CLASSE

Noise heard through speakers while utilizing CANBUS with CA-D200, AMP2, AMP5

Service Notice # 0012 Release date: March 26, 2015

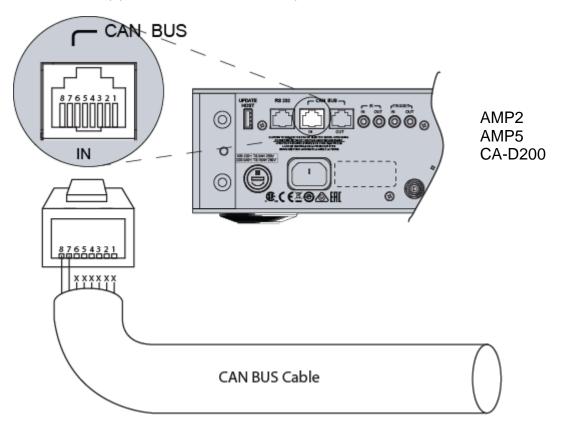
A ground loop is caused when connecting CANBUS to the CA-D200, AMP2 or AMP5.

Create a custom CAT-5 cable with only pins 7 and 8 connected at amplifier end.
